# 1000BASE-T Transmitter PSDs and 2.5/5G Salz SNR (aka 1000BASE-T PSDs Through the Ages)

IEEE P802.3bz 2.5/5GBASE-T Task Force

Pete Cibula (Intel)

Bonita Springs, FL – September 2015

## 1000BASE-T

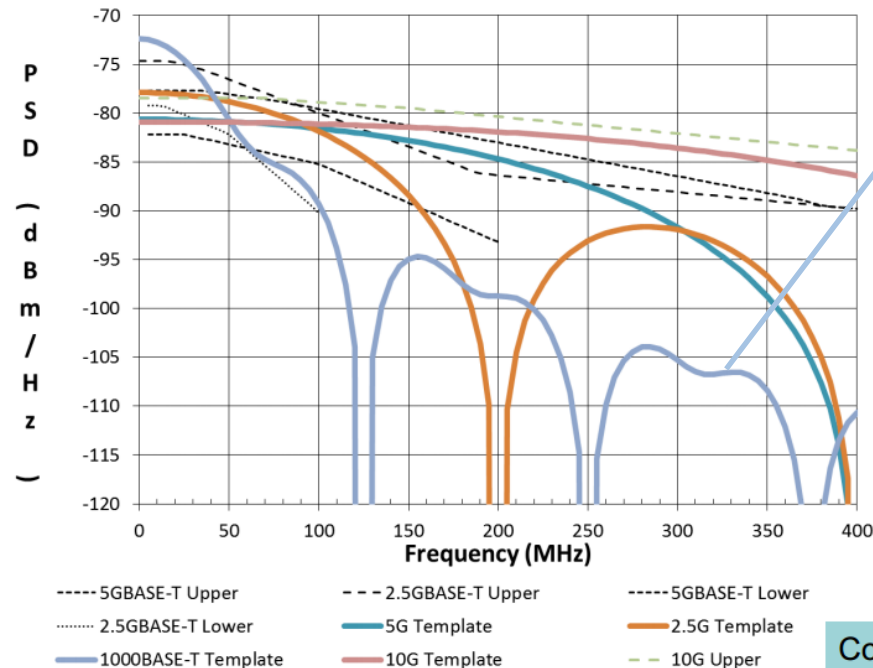
- A bit more difficult, specified as voltage mask w/rise and fall, not as a PSD, and uses pulse shaping filter:  $0.75 + 0.25z^{-1}$
- Approximation: (request for comment/revision)
  - 125 MSPS zero-order hold, specified pulse shaping filter, 1<sup>st</sup> order LPF at 100 MHz, 3.2dBm TX power

$$PSD(f) =$$
$$-72.38 + 20 \log_{10} \left[ \frac{\left| \sin \left( \frac{\pi f}{125} \right) \right|}{\frac{\pi f}{125}} \right] - 10 \log_{10} \left[ 1 + \left( \frac{f}{100} \right)^2 \right]$$
$$+ 10 \log_{10} \left[ 0.625 + 0.375 \cos \frac{2\pi f}{125} \right] \text{ dBm/Hz}$$

# 1000BASE-T PSDs

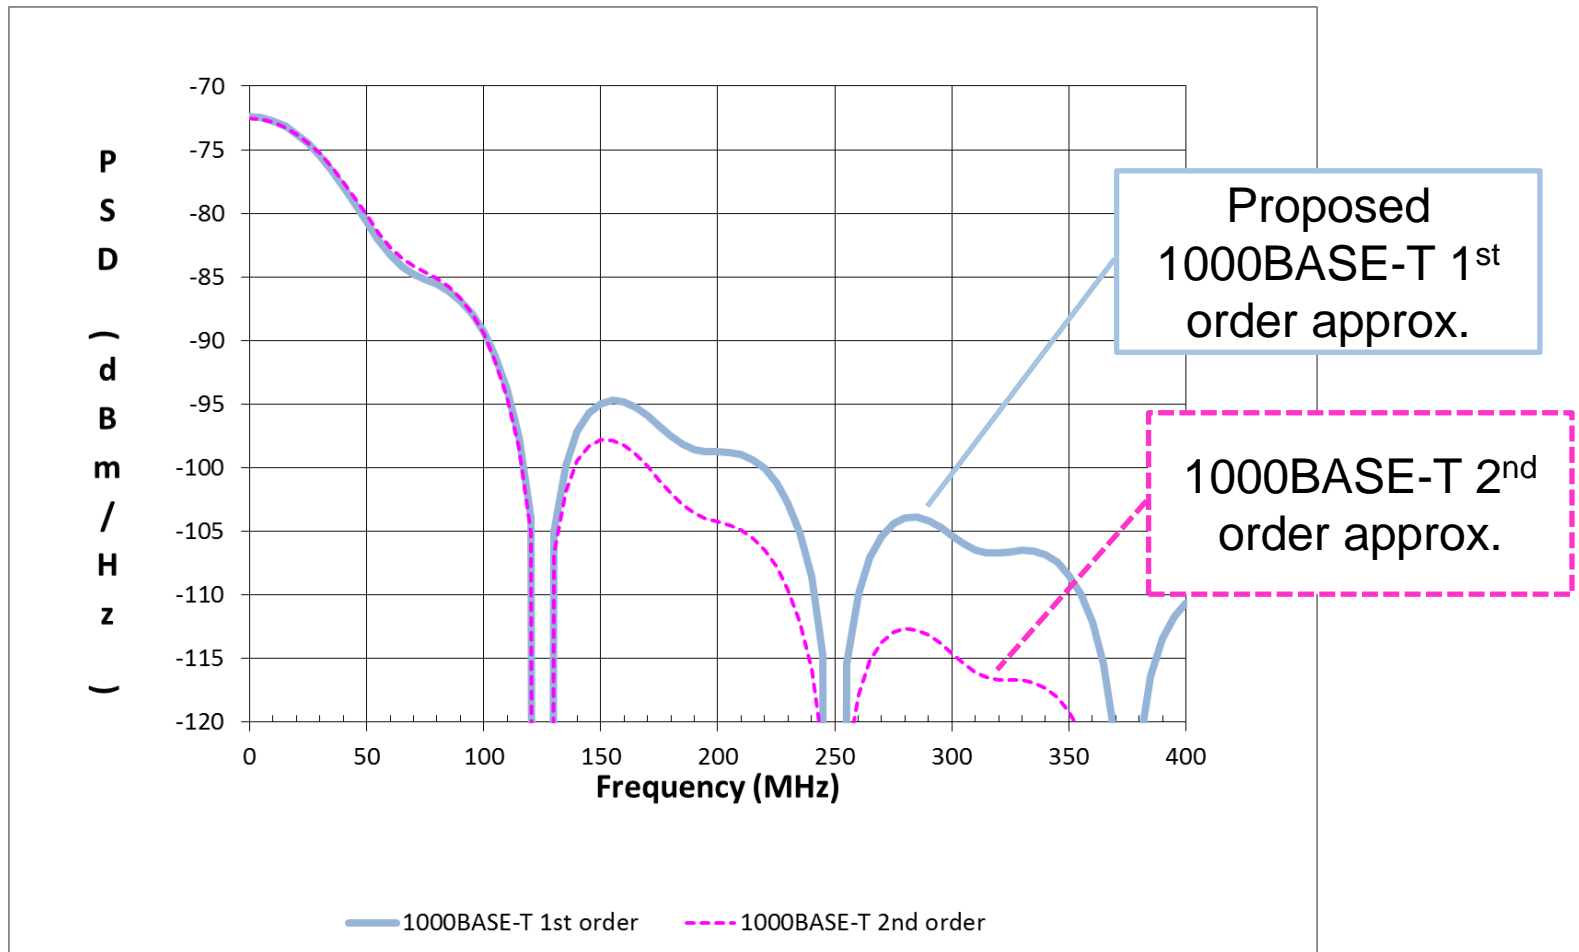
Proposed Template PSDs  
2<sup>nd</sup> order included for information only

# 1000BASE-T PSDs

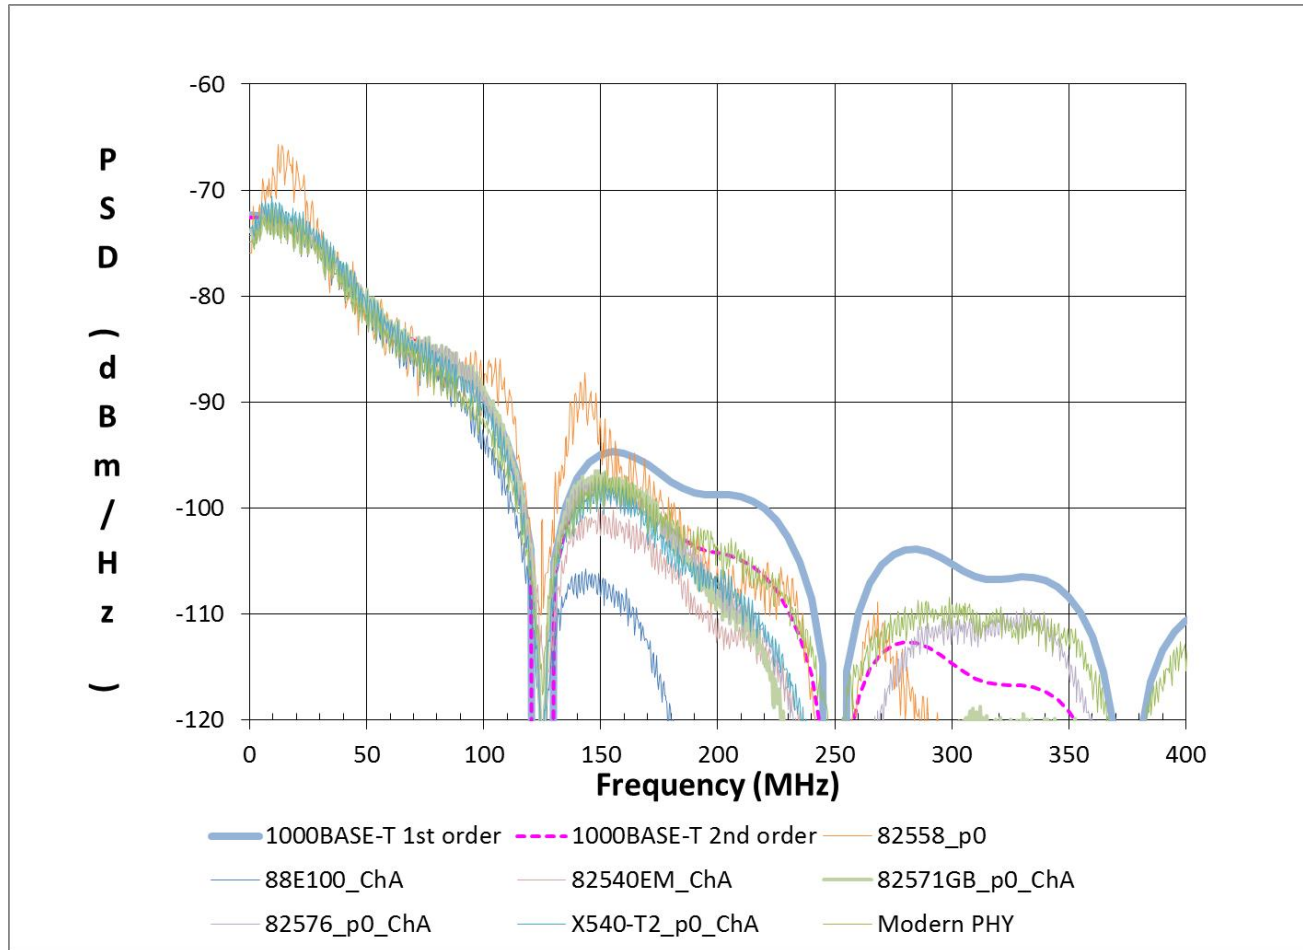
+ 100BASE-TX (c 1998) – Is this a concern?
